**OPERABLE UNIT 5
OPERATIONAL AREA PHASE I INVESTIGATION
AREA 3 FIELD REPORT**

**MOUND PLANT
MIAMISBURG, OHIO**

Final (Revision 1)

US DOE MOUND PLANT
Operable Unit 5
Operational Area 3 Field Report
February 1995
Ohio EPA Comments
Page 2 of 2

Figure 2.3. Locations of Elevated Surface Soil Radiological Activity (Pu-238)

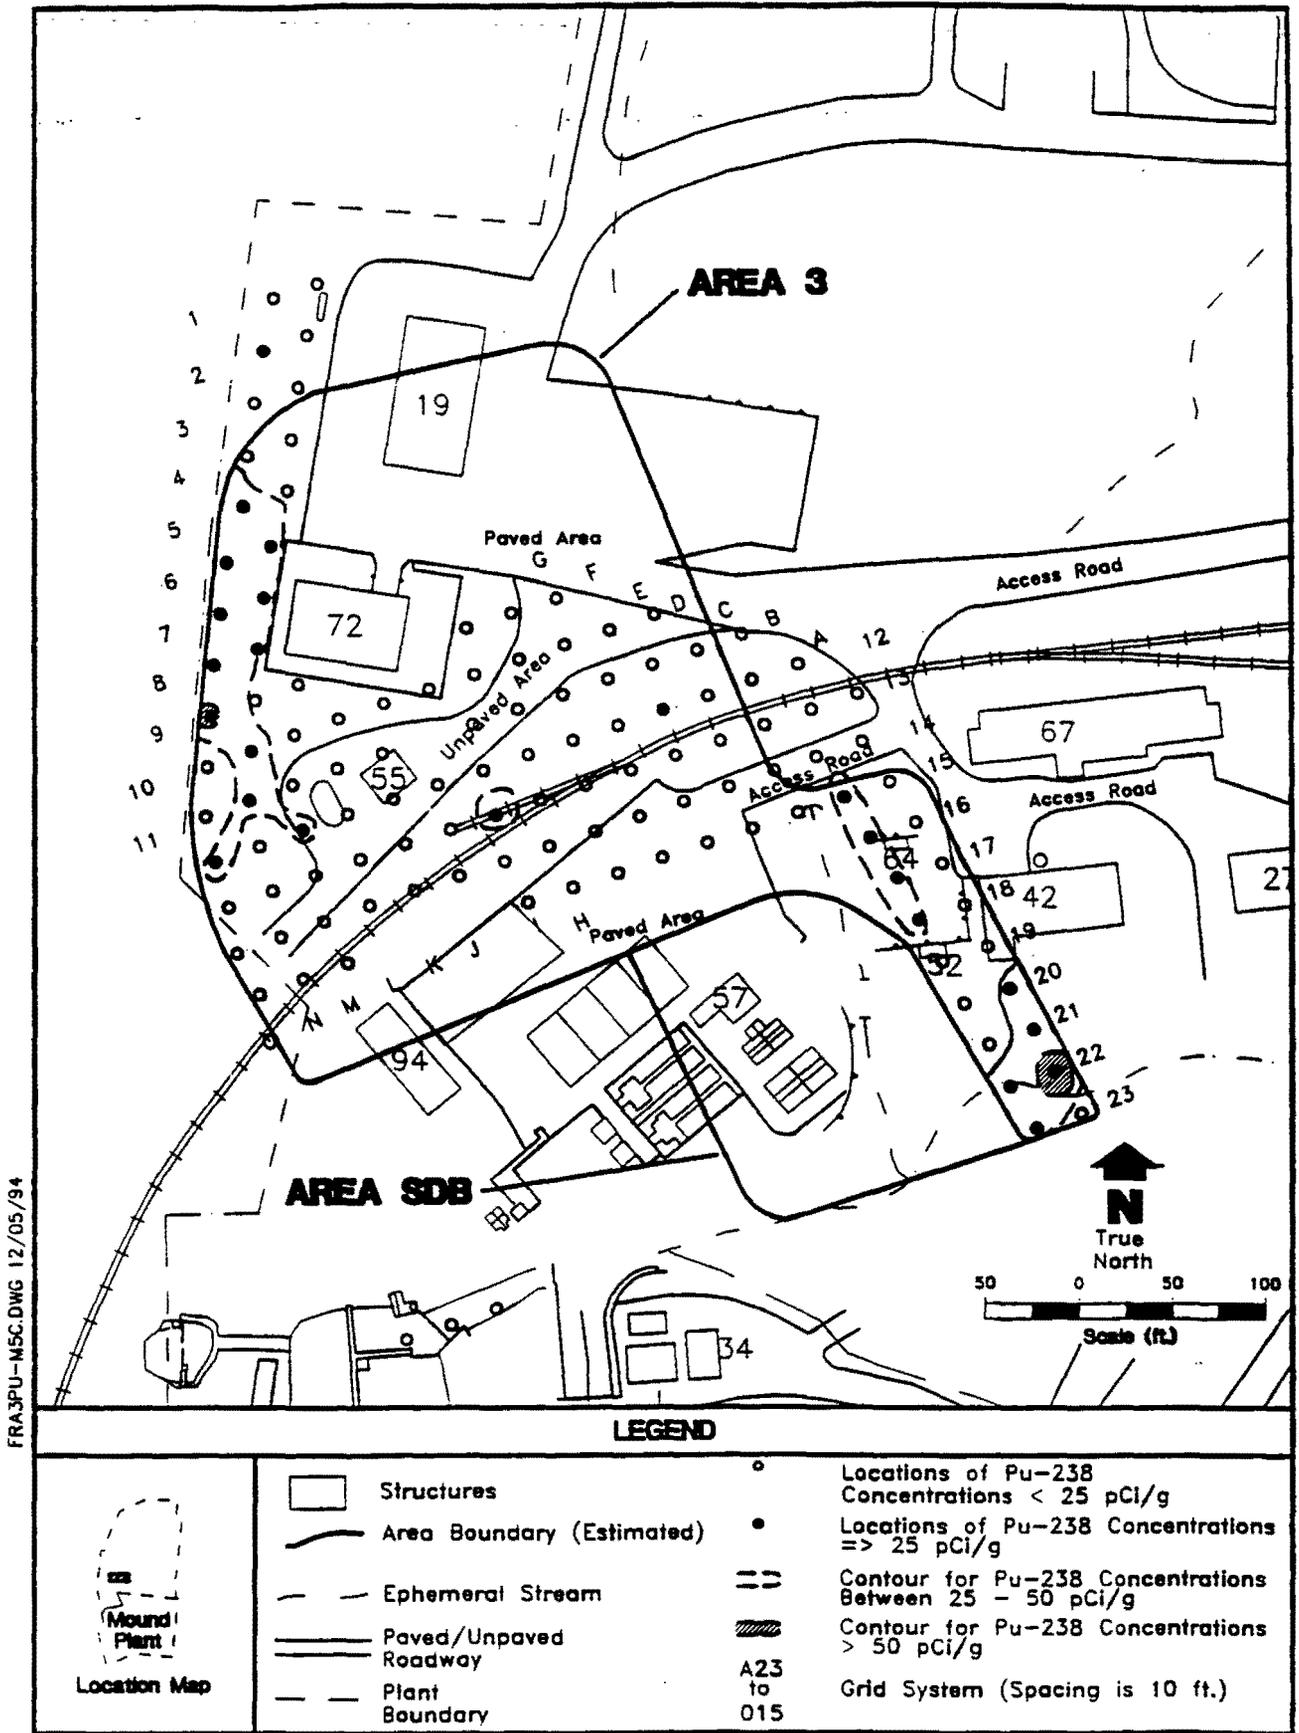
Comment #3: Section 2.1.4, Page 2-7, Last Sentence, and Figure 2.3:

Elevated radiological activity greater than 50 pCi/g exists at or near the southeast and northwest boundaries of the sampling grid (e.g., at O9 and A22 in Figure 2.3). We agree with the statement that results may indicate that contamination exists outside the boundaries of the sampling grid, and therefore believe that it should be expanded.

Response #3: Comment noted. The findings reported in the Area 3 Field Report will be used as a basis for issuance of an addendum to the OU5 Work Plan for Ohio EPA and USEPA approval. The addendum will specify the expansion of the study area as part of the Phase II activities.
